Assessment report to Sydney Central City Planning Panel

PPS-2018CCI032

| DA number | MOD-18-00331 to JRPP-15-2703 | Date of lodgement | 2 August 2018 |
| Proposed development | Modify the approved 6 x 4 storey residential development to increase the developable area by 655 m ² ; increase the number of units within Stage 2 from 100 to 115; increase in height of buildings with Buildings D, E & F exceeding the height limit with part of the 4th level, feature walls, and lift overruns by 0.2 to 1.62 m; change in the unit mix; increase the basement size to provide additional parking; and changes to landscaping and drainage works. | | |

7.2 Proposed access from Schofield Road

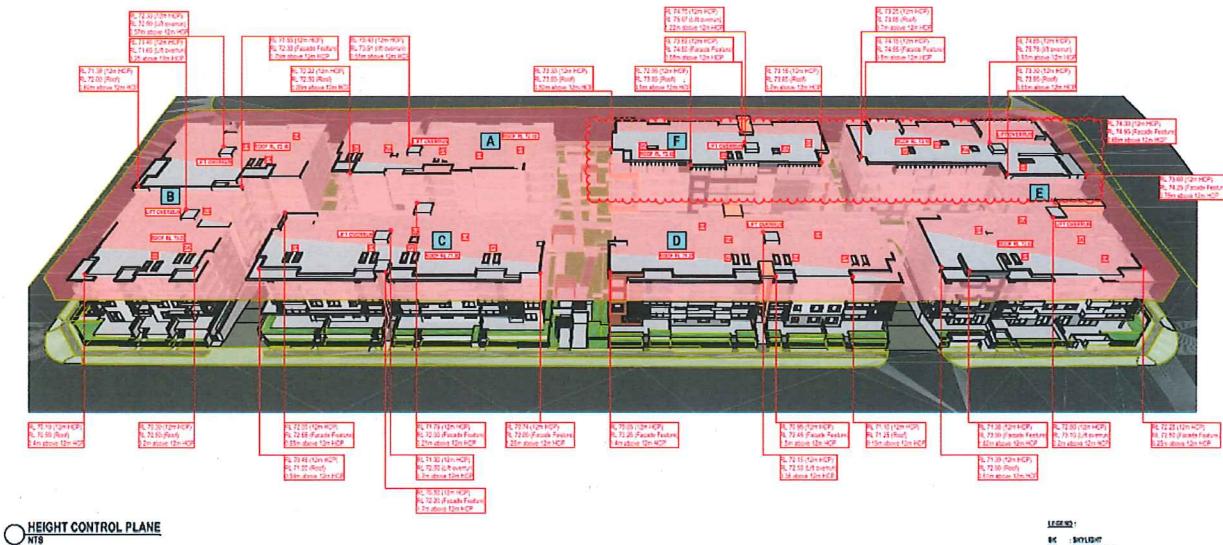
- 7.2.1 The proposed amendment requires the Applicant to obtain written concurrence from Council's Traffic Management team and TfNSW that the proposed access configuration is compliant and safe. This concerns the access and egress from the proposed development onto Schofields Road as detailed on the current engineering plans.

- 7.2.2 The current proposed temporary road design configuration for access to Schofields Road is required to provide a safe intersection. The design has identified serious safety risks for intended traffic access and egress from Schofields Road into and out of the development.

- 7.2.3 Sight distance across the intersection shown in the current design for the amended proposal will be extremely difficult for both traffic accessing and leaving the site from this location due to the steep grade of the proposed temporary road to and from Schofields Road. Based on the current design, negotiating this intersection will be dangerous for all users. Traffic travelling along Schofields Road could also be negatively impacted.

- 7.2.4 Council's Engineering team has not received written confirmation from the TfNSW endorsing the proposed temporary road intersection design onto Schofields Road and Council's Traffic Management team can't endorse a design on a State road without TfNSW first approving it.

7.2.5 Council officers met with TfNSW on 25 May 2020 to discuss the proposed access off Schofields Road for this development. TfNSW has not provided concurrence for the proposed temporary access arrangement. Its latest correspondence dated 26 May 2020 stated that preference is for temporary vehicular access to be relocated to the south-west corner and for the local road levels to be raised to match Schofields Road. Amended plans were requested from the Applicant so that TfNSW could complete their assessment of this application under Section 138 of the Roads Act, 1993. To date these have not been received.
